From: [REDACTED]
To: [REDACTED]
CC: [REDACTED]
Sent: 2/26/2021 7:53:08 AM
Subject: RE: O8W-PM [REDACTED] - Bucks Creek 1101 Phase 1,2&3 - Pre-Engineering Meeting

Bucks Creek 1101- PM# [REDACTED] Overview Map

PM [REDACTED] (Phase 2)

3. Rock Creek Bridge Crossing

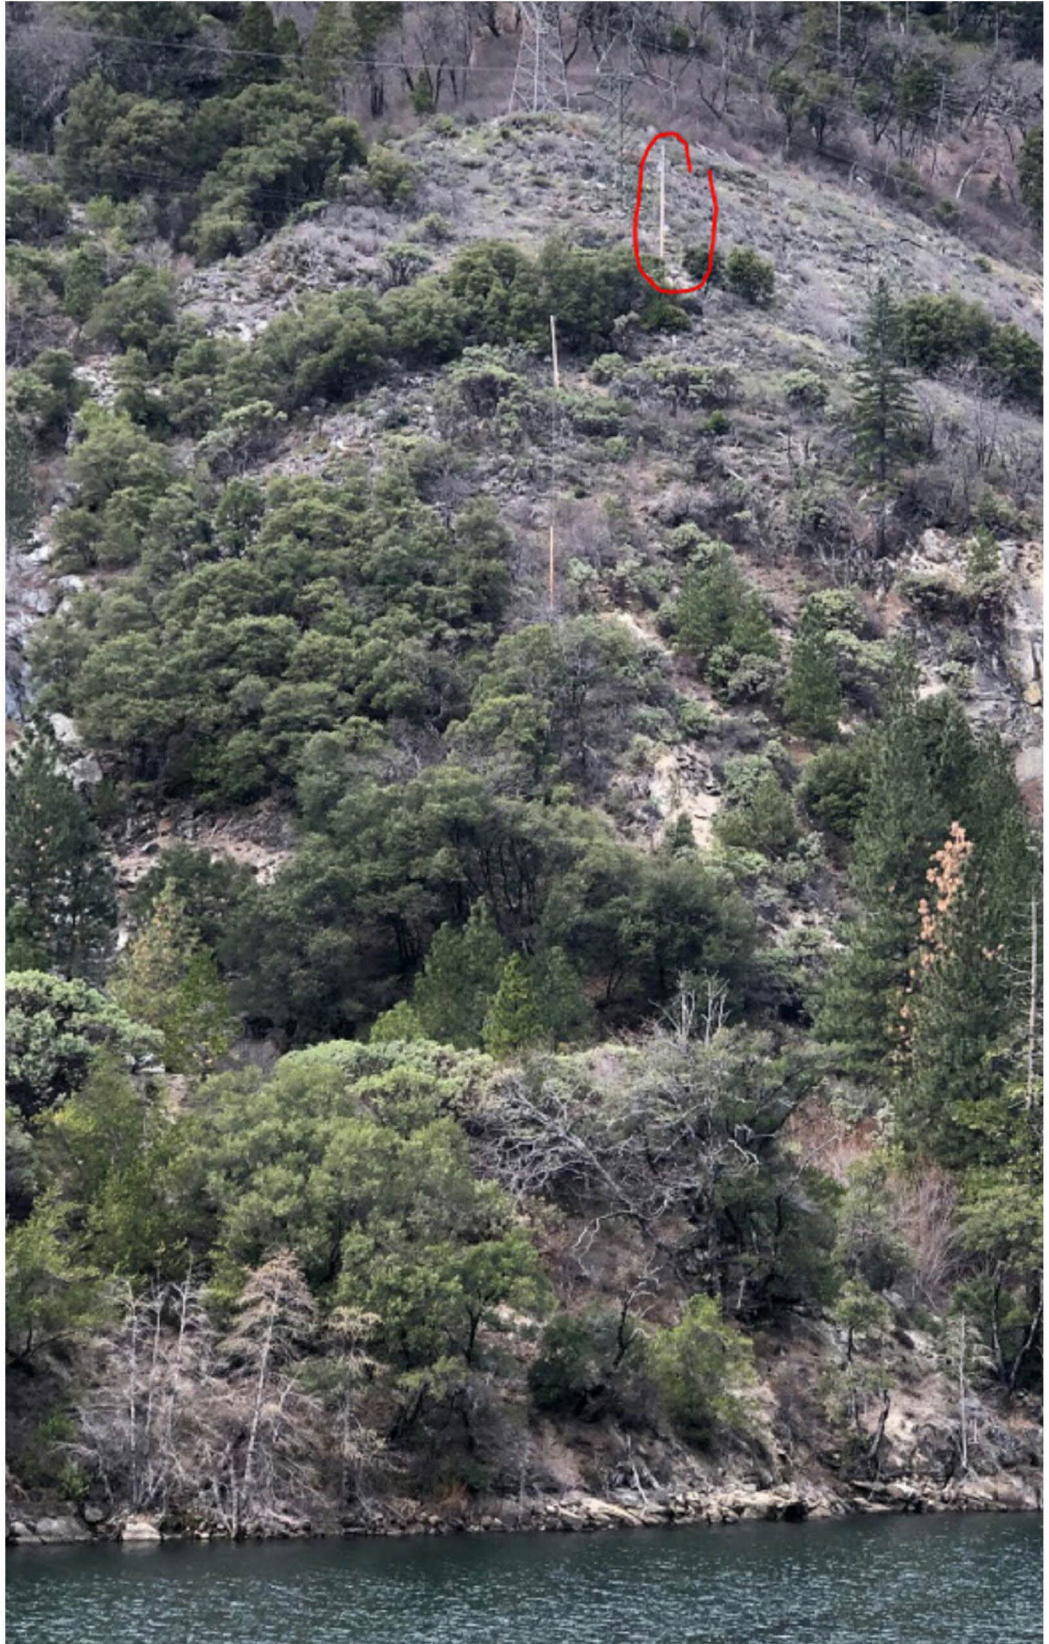
- a. Scope is not clear for this crossing since it leads us to a 'what-if' scenario of, if Caltrans doesn't allow the conduits to be attached to the existing bridge we should span the river OH. This will need to be discussed with Caltrans to first determine 'if' we can attach to their bridge before scope is locked.
